DEPARTMENT OF TRANSPORT

**INFORMATION CIRCULARS TO  
AIR ENGINEERS AND AIRCRAFT OWNERS**

### INFORMATION CIRCULARS TO AIR ENGINEERS AND AIRCRAFT OWNERS

1928-1939

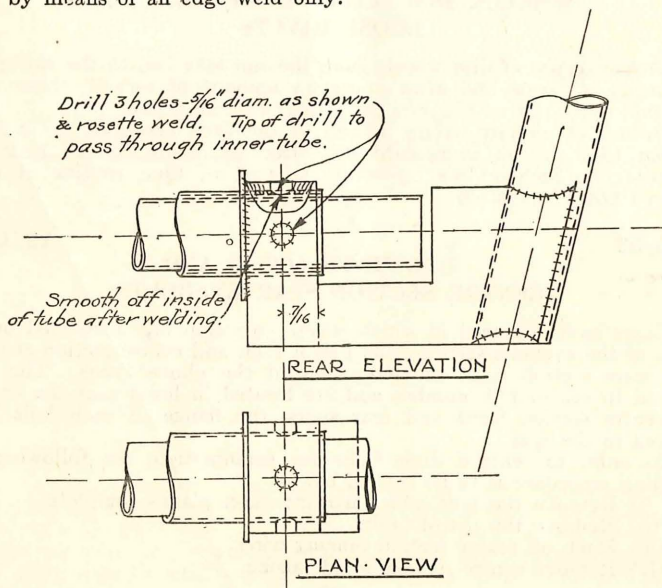
A number of Gipsy I connecting rods, Part Number 800-10, have the two oil holes in the underside of the gudgeon pin boss drilled close together so that they merge into one hole where they enter the gudgeon pin bore. Rods so drilled are very prone to cracking and their maximum safe life has consequently been fixed at 600 hours. Rods which have completed 600 hours' running are to be removed from engines and replaced by others of later manufacture, as listed below, and where no evidence of the number of hours' running can be produced, they are to be renewed within two years of the time the engine was first put into service.

- (i) Rods in which the holes are approximately 11 mm. apart where they enter the gudgeon pin bore.
- (ii) Rods having the holes omitted entirely.

Certificates of Airworthiness of any aircraft fitted with engines of the types referred to in this Notice shall be liable to suspension or cancellation if the requirements herein have not been complied with and Air Engineers must not sign daily certificates in respect of such aircraft unless the instructions have been satisfactorily carried out.
